P-10957-1

S2972

28022

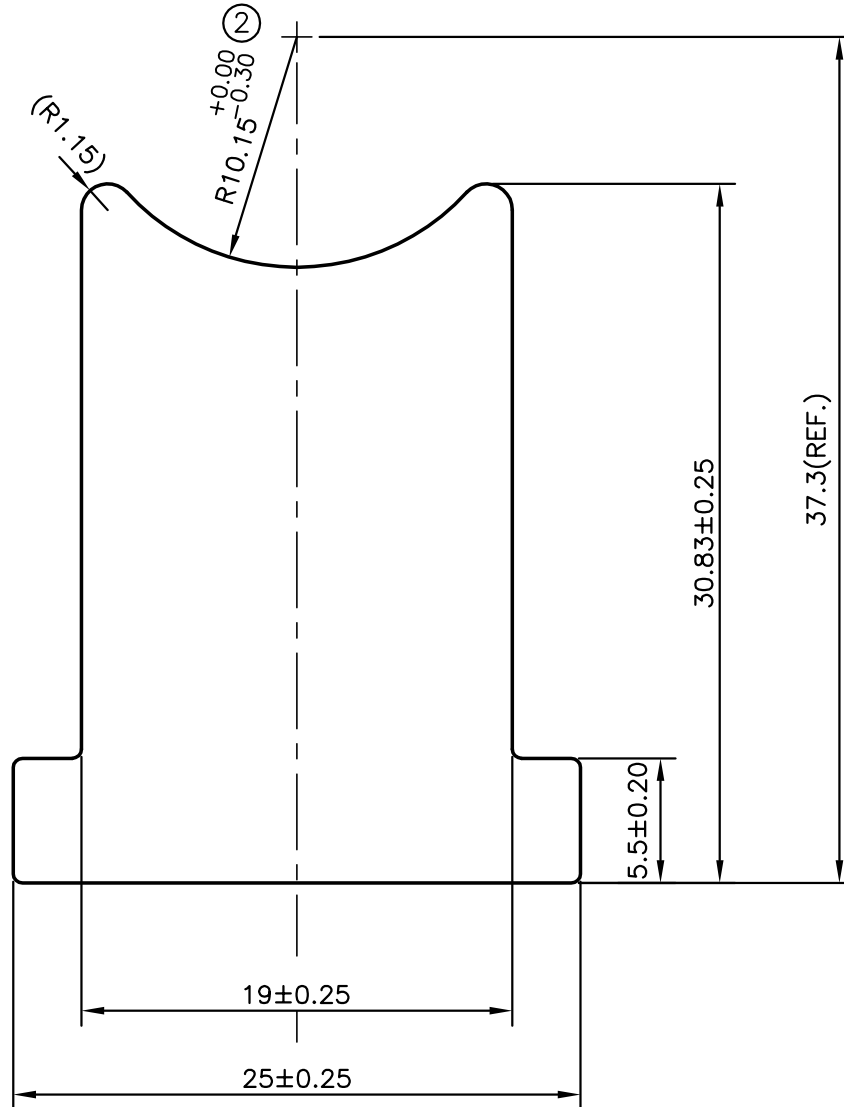
ISSUE-2 :- RADIUS CHANGED FROM 10.1 TO 10.15 & TOLERANCE ADDED  
 WEIGHT ALSO CHANGED FROM 1.563 kg/M TO 1.561 kg/M
